EAGLE MOUNTAIN PLANNING COMMISSION MEETING

May 12, 2020, 5:30 PM

EAGLE MOUNTAIN CITY
PLANNING COMMISSION MEETING
MAY 12, 2020

TITLE:	Auto Zone Site Plan & Recorded Plat Amendment - Public Hearing
ITEM TYPE:	Recorded Plat Amendment & Site Plan
APPLICANT:	Colby Anderson

C1.1

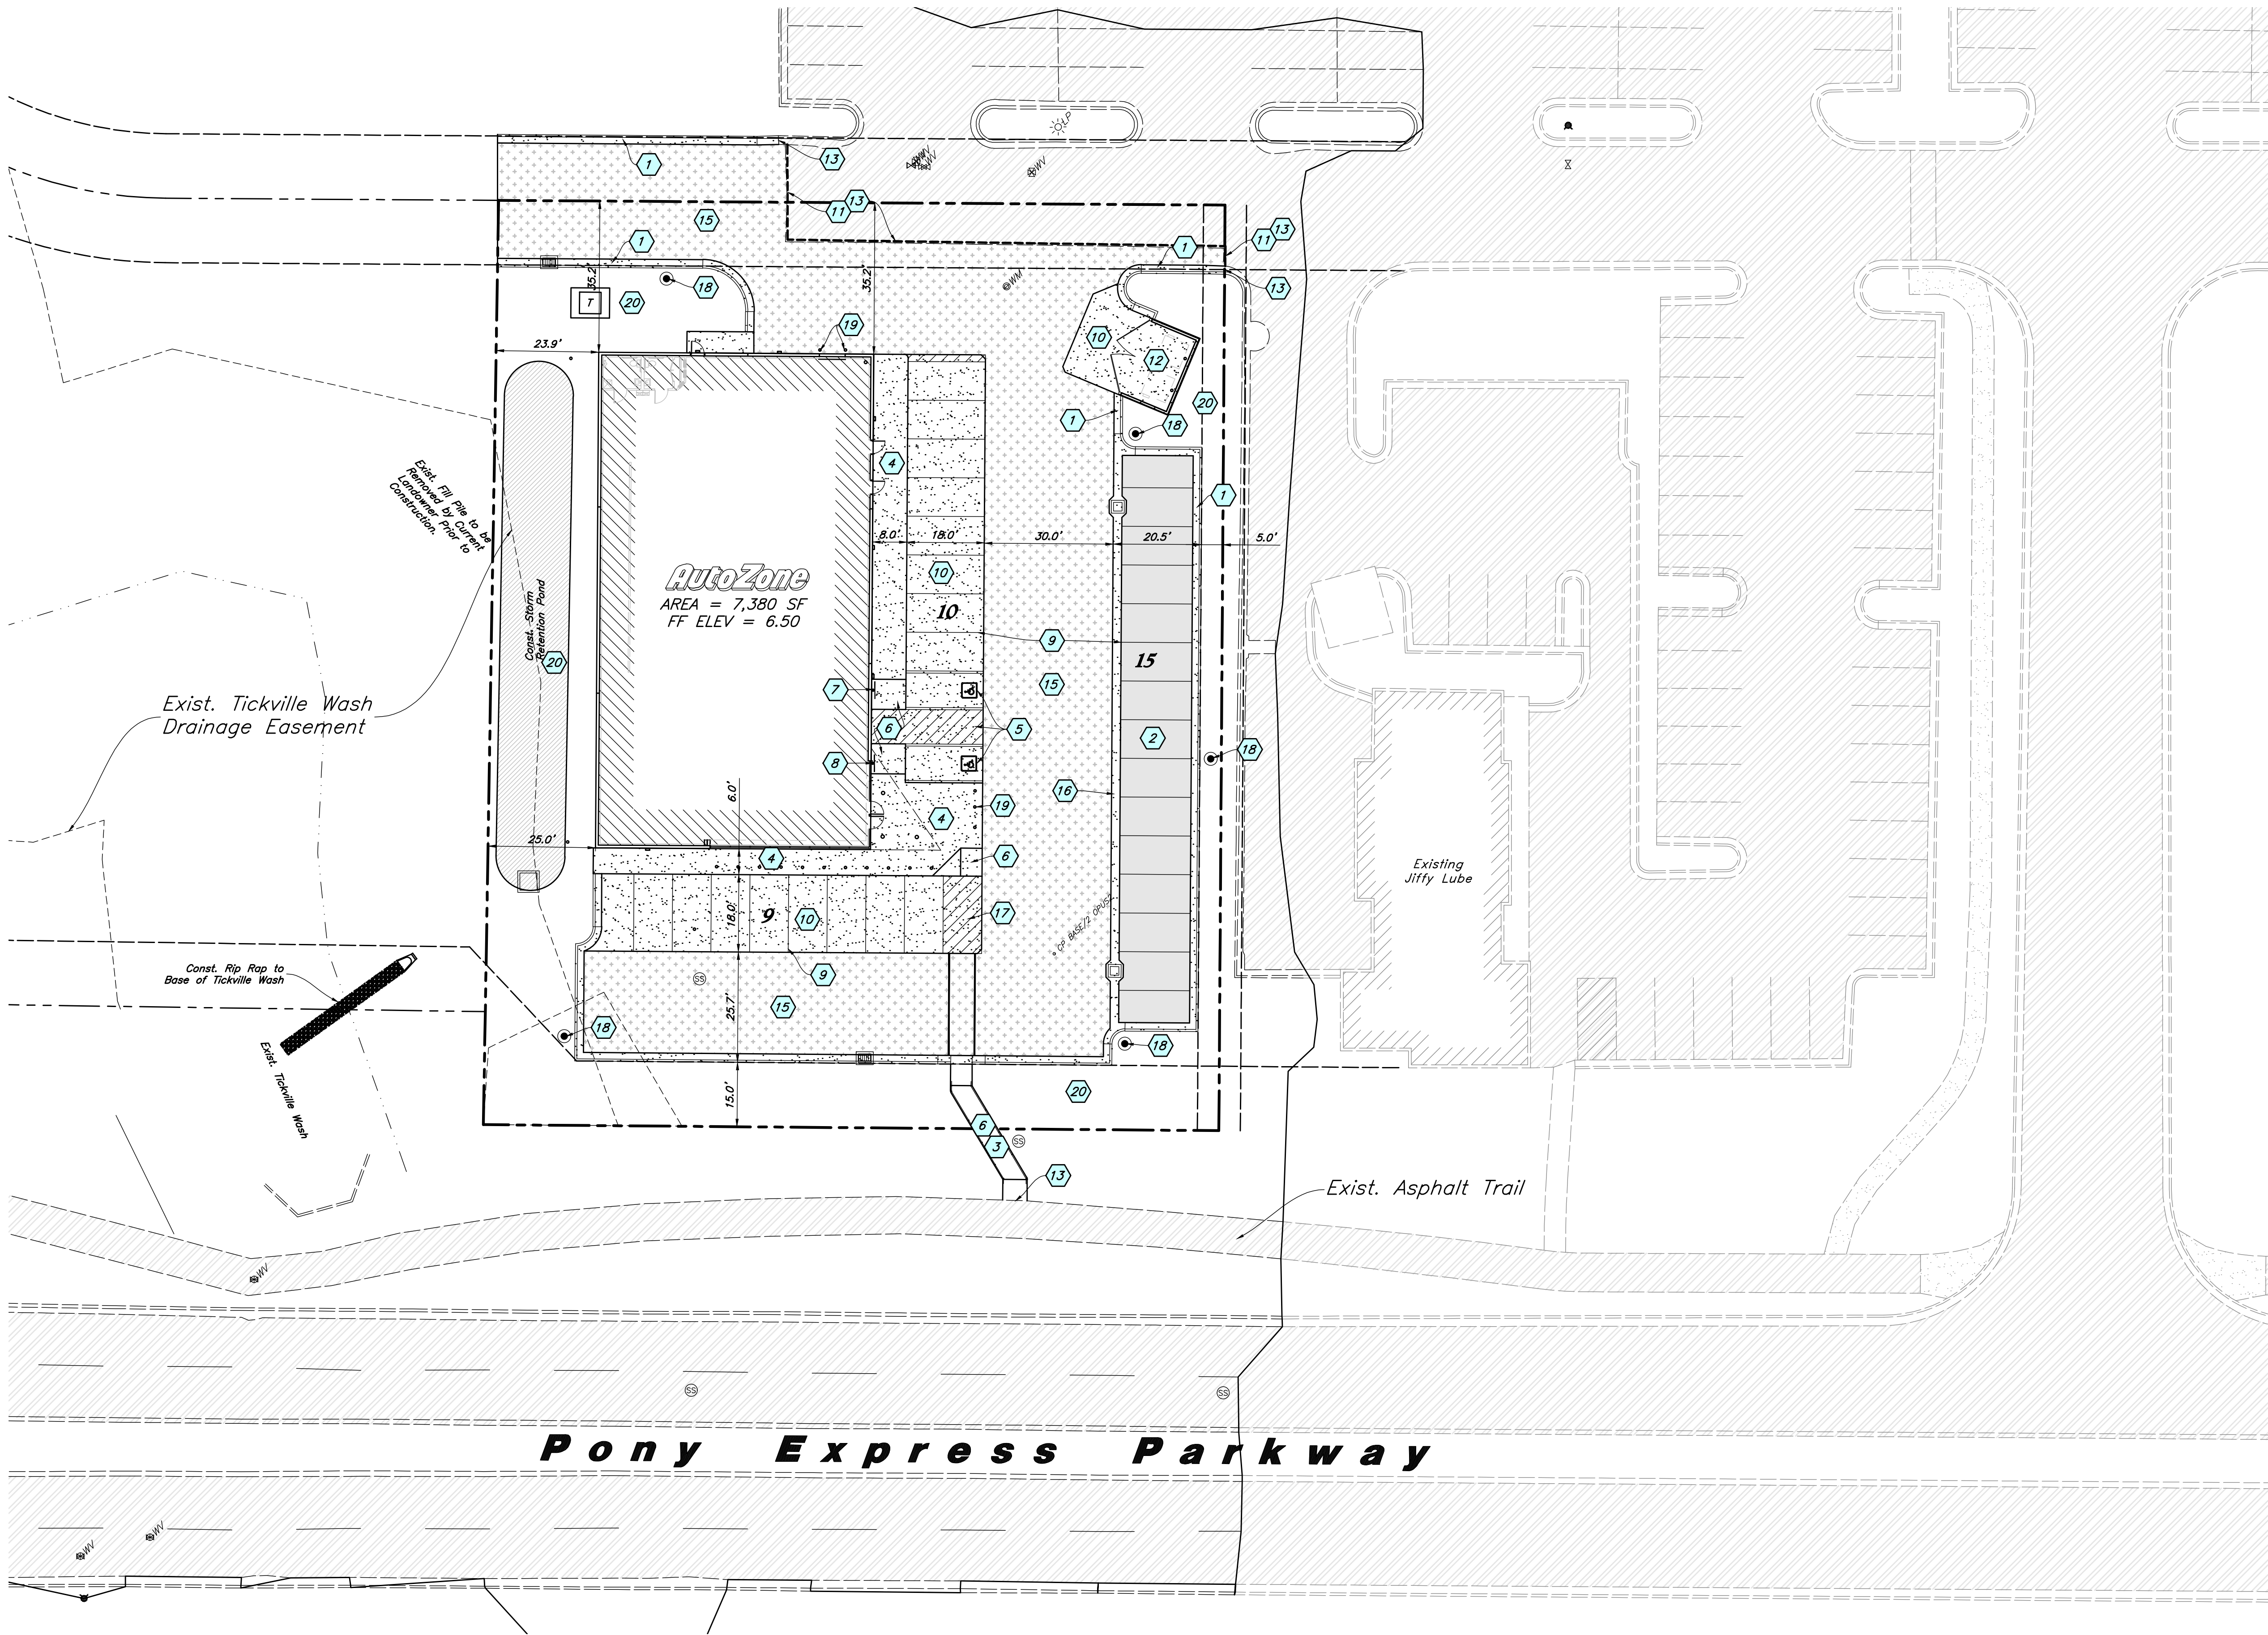
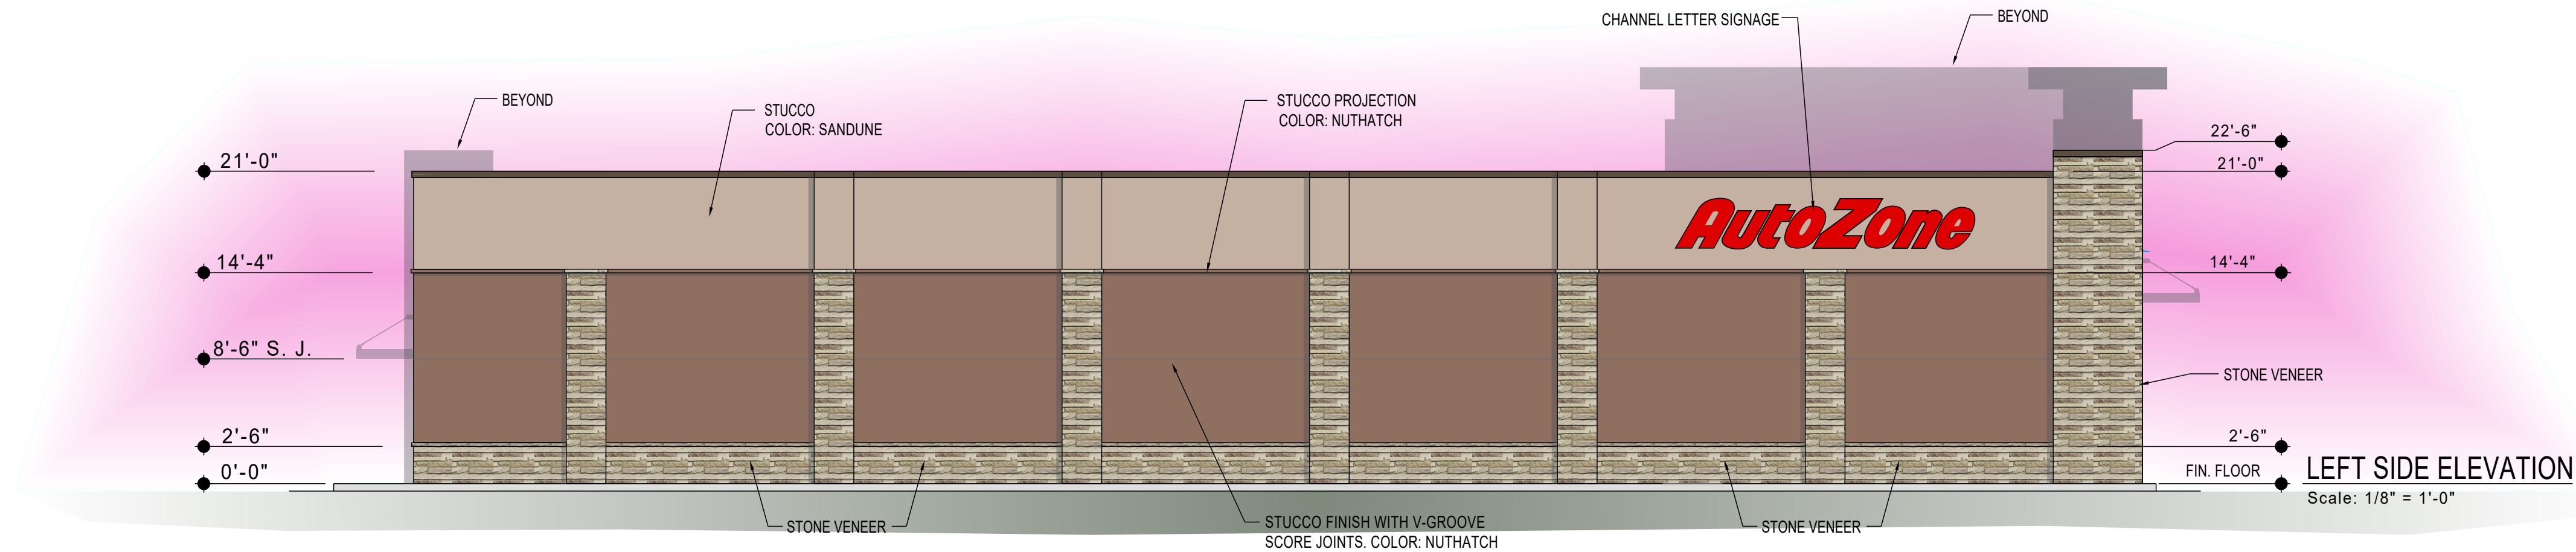
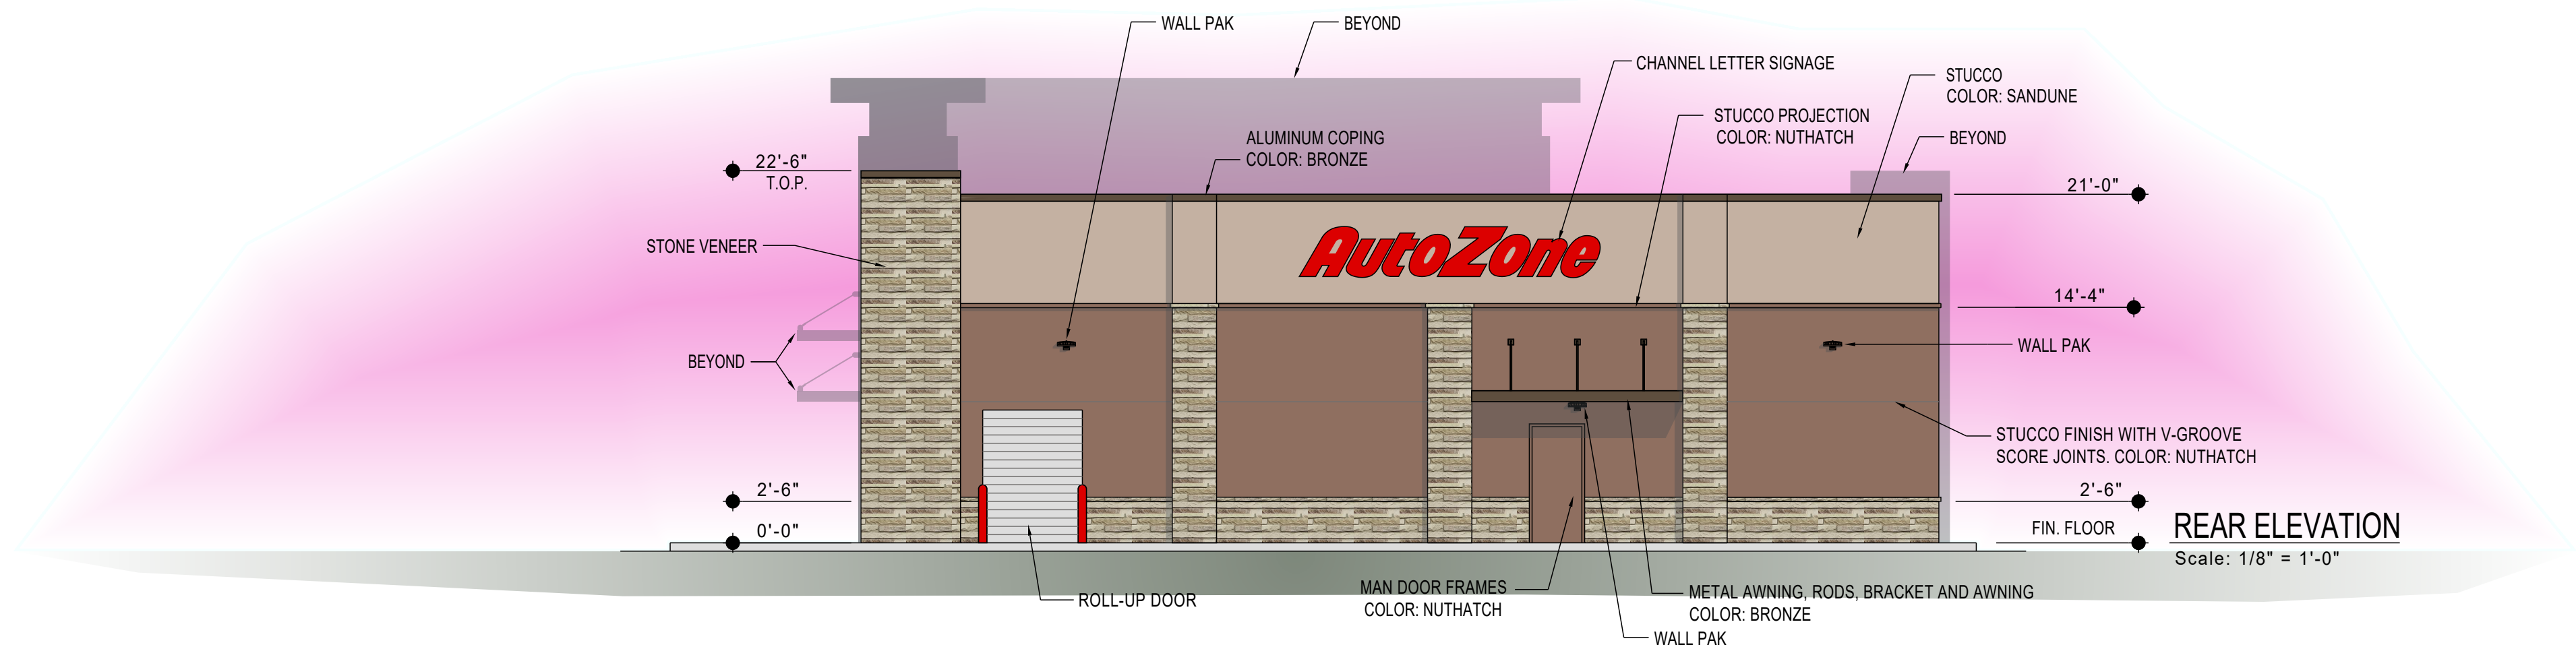
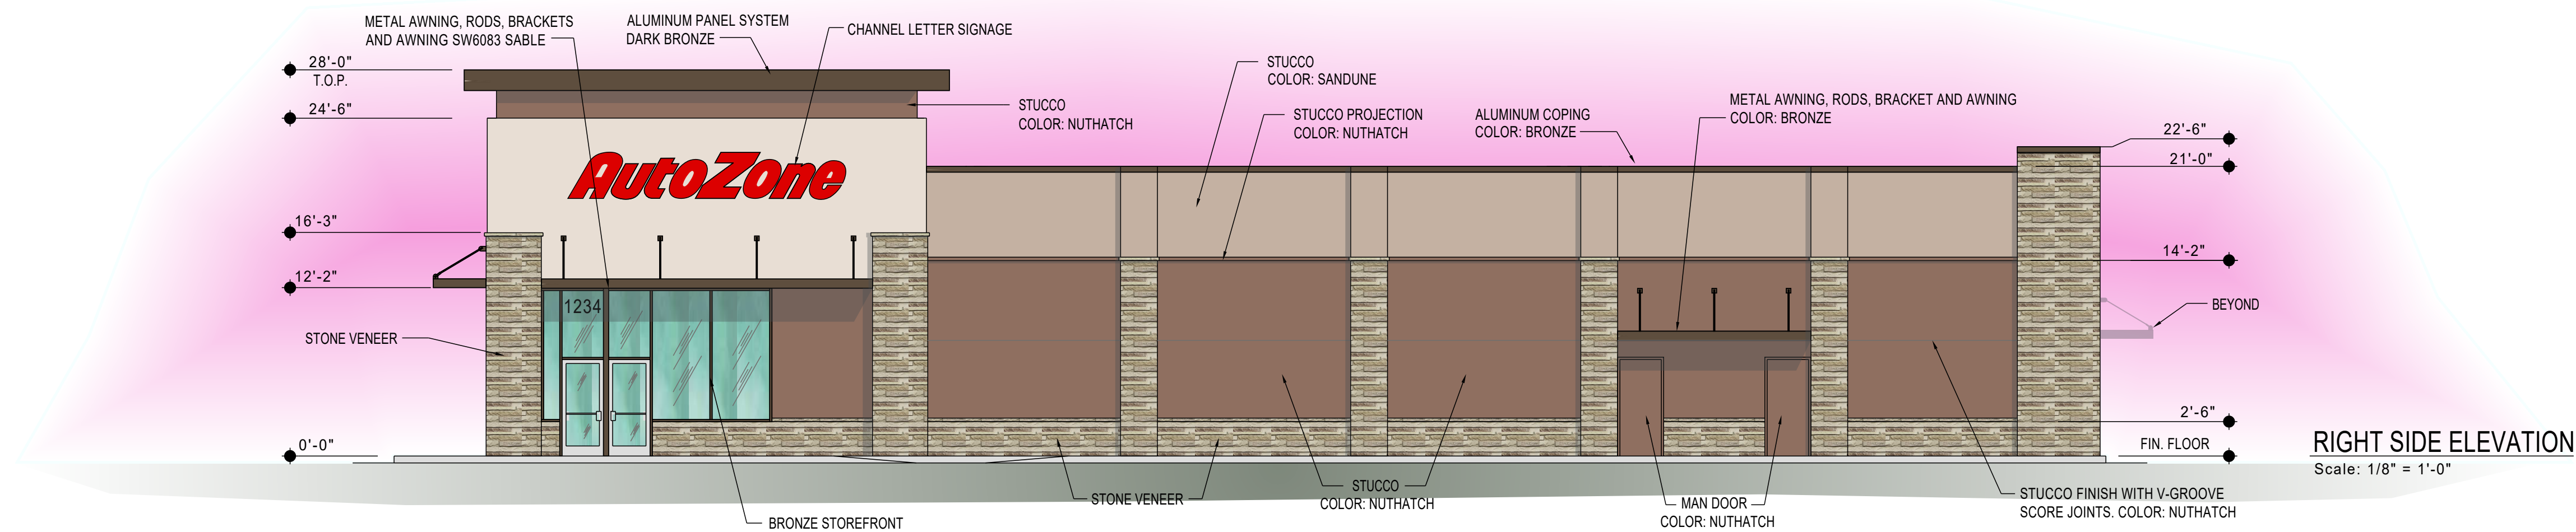
This an application for a Recorded Plat Amendment and proposed Site Plan for an Auto Zone supply store located on lot 7 in the Porter's Crossing Town Center along Pony Express Pkwy. The lot is 2.39 acres with a majority of the lot in the Tickville Wash. As a part of this project the applicant is doing a recorded plat amendment to remove the Tickville Wash portion from Lot 7, creating a separate lot for the Tickville Wash.

1. The applicant moves the building forward to the front of lot 7 to comply with the City's Commercial design standards.
2. The parking currently located in the front of the building is moved or remove form the site.

1. The applicant moves the building to the front of the lot along Pony Express Pkwy.
2. The applicant moves or removes the parking in the front of the building.
3. A lighting plan is submitted that complies with the dark sky lighting ordinance.
4. Any conditions that the Planning Commission deems appropriate.
